INSTRUCTIONAL BULLETIN NO. 12-18

Regarding Revised Standard Drawing and Section V of the Design Guidelines

STANDARD PRECAST CIRCULAR NO. 14RB CATCH BASIN

STANDARD PRECAST CIRCULAR NO. 14RB CATCH BASIN

3-20-00 D-CB-14RB

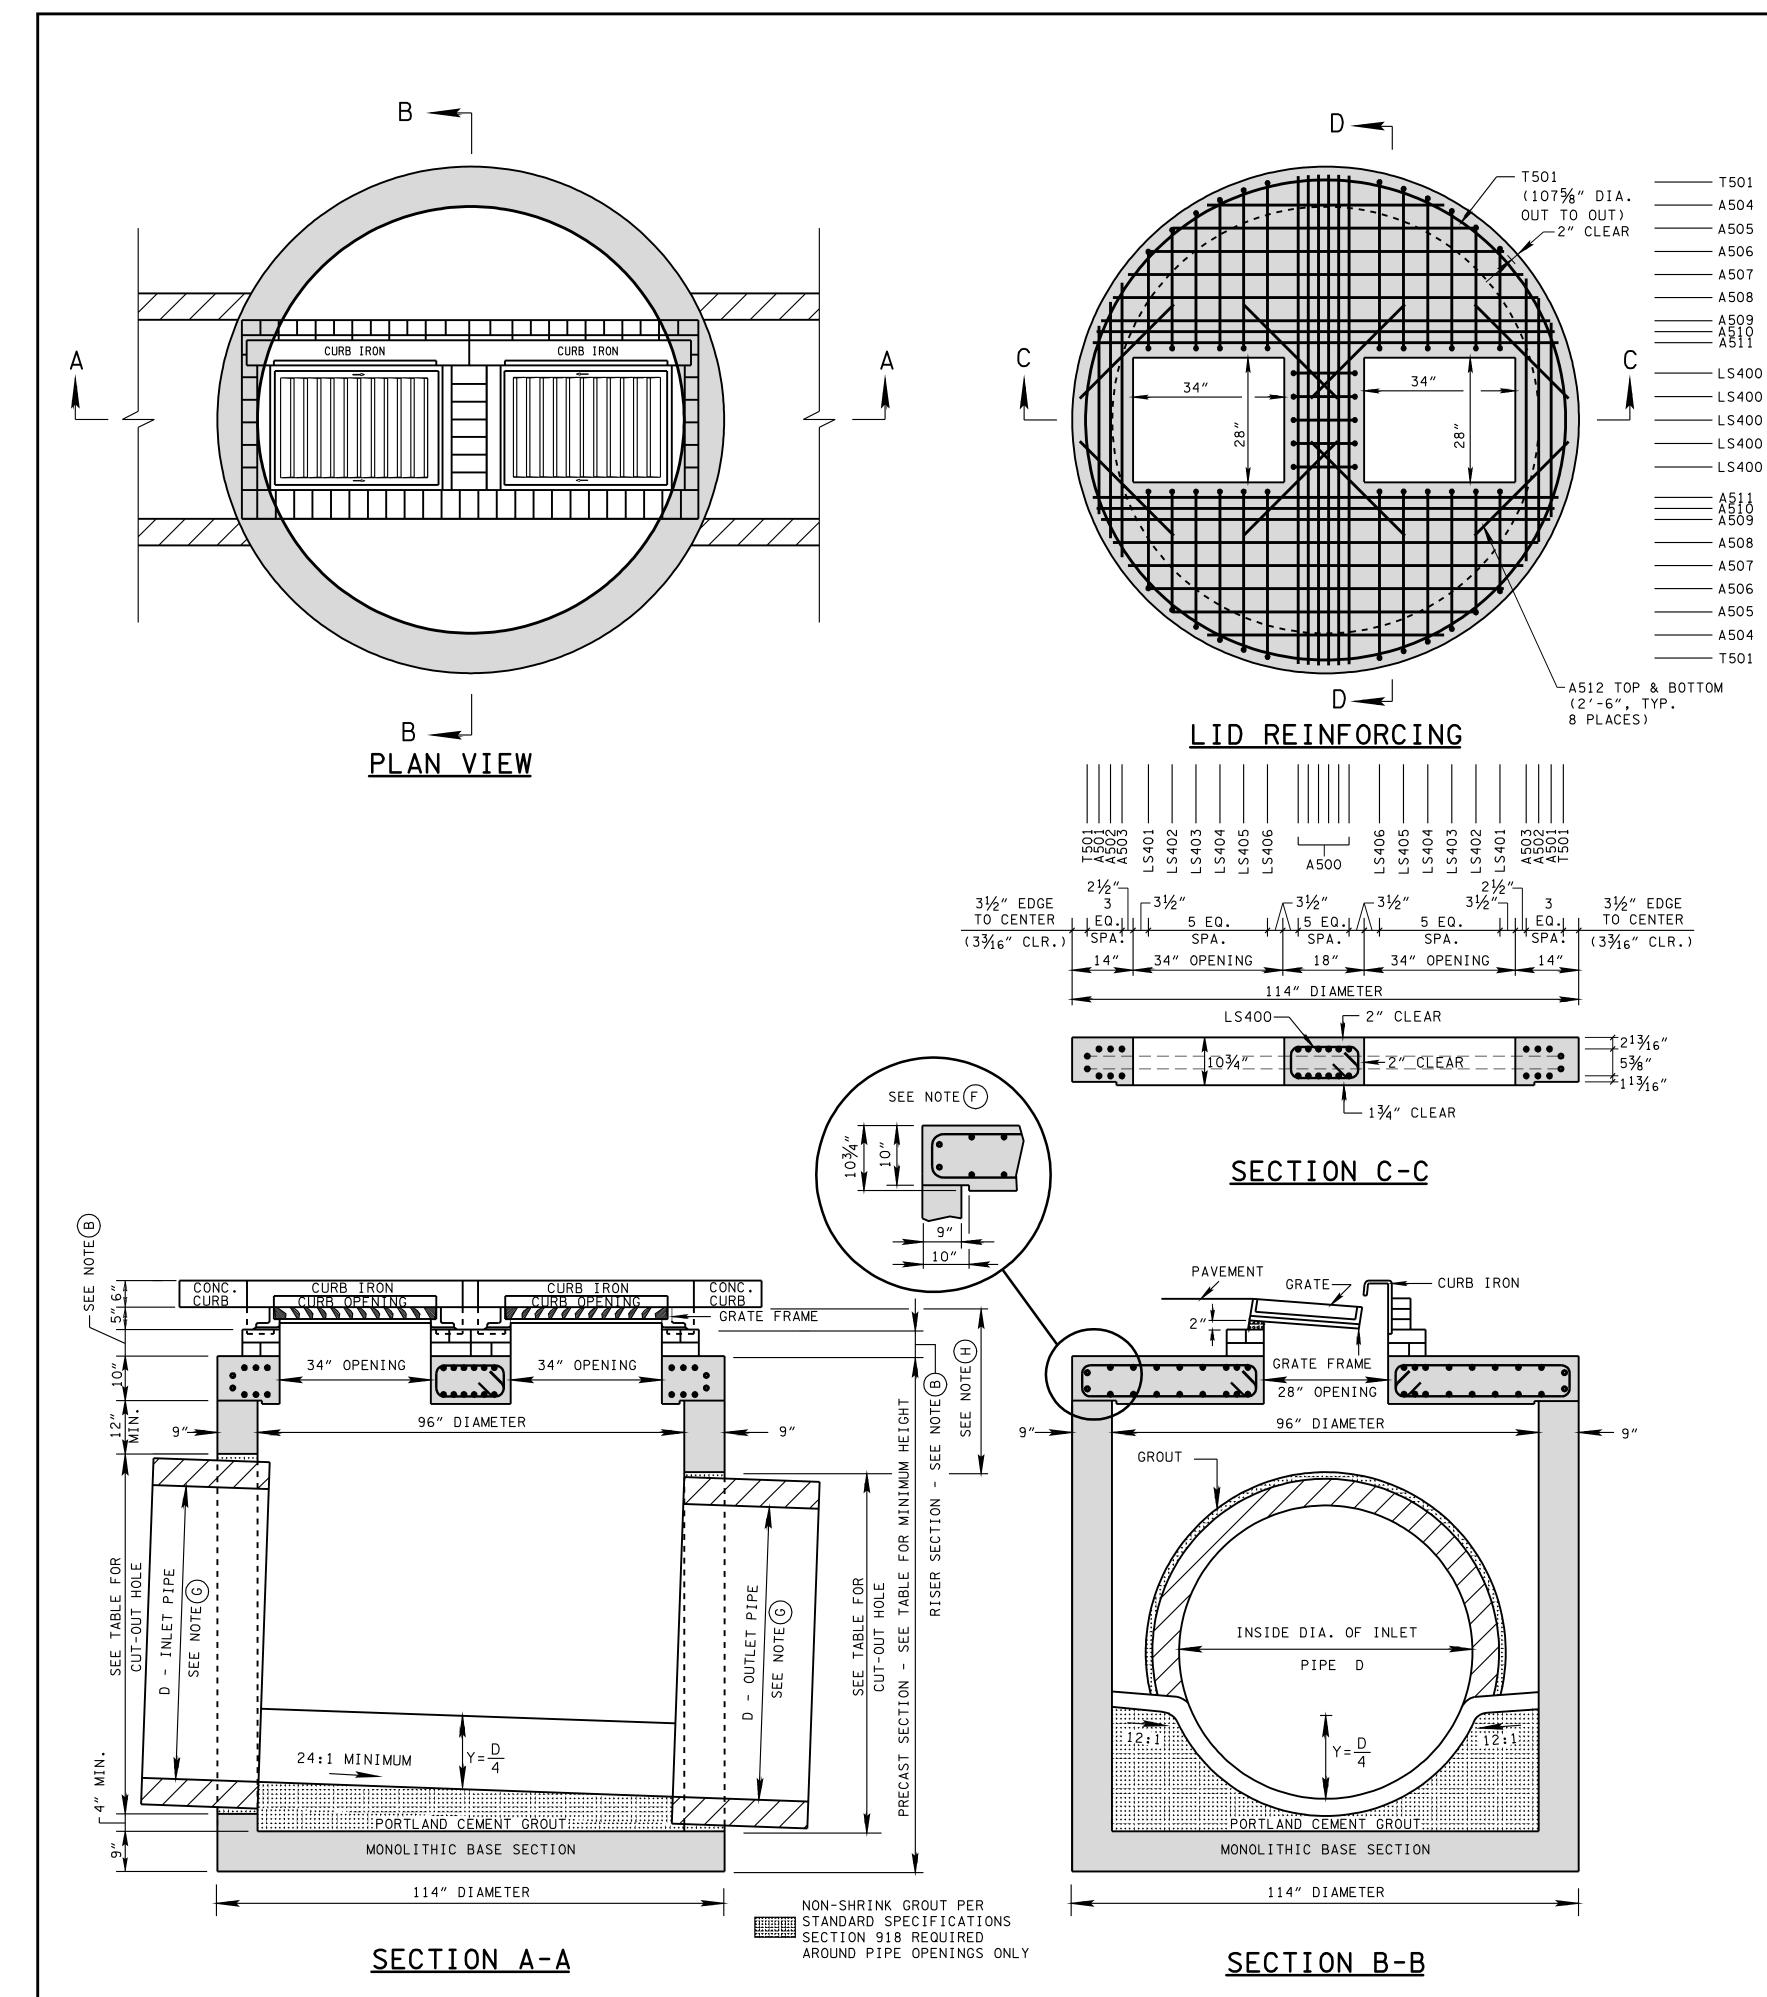
REV. 8-01-12: REVISED CATCH BASIN LID FOR COMPLIANCE WITH AASHTO LRFD BRIDGE DESIGN SPECIFICATIONS, 4TH EDITION WITH INTERIMS. REVISED REINFORCING,

REV. 8-15-12: REVISED CATCH BASIN DIMENSIONS TABLE

CAT	FOR DESIGN USE ONLY			
INSIDE DIAMETER (D) OF PIPE (INCHES)	PIPE WALL THICKNESS (INCHES)	DIAMETER OF CUT-OUT HOLES (INCHES)	PRECAST SECTION MIN. HEIGHTS (INCHES)	CATCH BASIN MINIMUM DESIGN DEPTH (FEET)
18	21/2	25	60	4.38
24	3	32	67	4.92
30	31/2	39	74	5.46
36	4	46	81	6.00
42	41/2	53	88	6.54
48	5	60	95	7.08
54	5½	67	102	7.63
60	6	74	109	8.17
66	6½	81	116	8.71
